**Project:** Cadenza – MetroLink Submission

**Job No:** 18-020

**Subject:** Review of MetroLink Rail Order

**Date:** 20 March 2024

Figure 10: Imposed vertical Loadings - Bored Tunnel

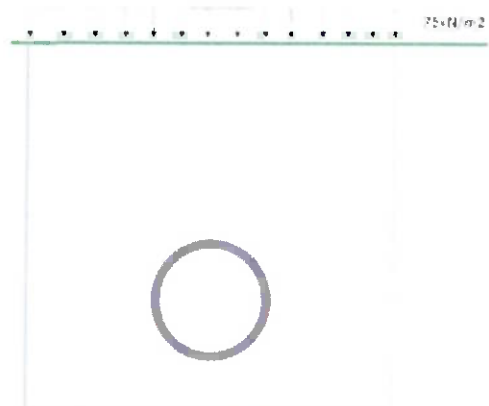
In addition, section 2.1.4 of the Draft Guidance Note For Developers document and figure 10 confirm:-

- The tunnel lining design has been prepared on the basis that the bored tunnels are able to carry an over-site load of  $75\text{kN/m}^2$ . The imposed vertical loading for the tunnels is shown diagrammatically in the following.

If this level of load limiting is imposed due to the Metrolink Tunnel, it would not be possible to build a traditional house, let alone extend or rebuild the Cadenza Building, which imposes  $1000\text{kN/m}^2$  at the underside of the foundation level directly above the tunnel.

The conditions imposed by the Metrolink Tunnel would preclude either the vertical extension or future redevelopment of the Cadenza Building, and the exclusion zone would also appear to preclude the deepening of the existing basement level.

We are concerned that TII has not adequately considered the level of foundation loading so close to the Metrolink Tunnel.

TII should be required to design and construct the tunnel to ensure that the tunnel's loading tolerances beneath the Property will be capable of supporting the construction of an additional two storeys on top of the Cadenza Building.
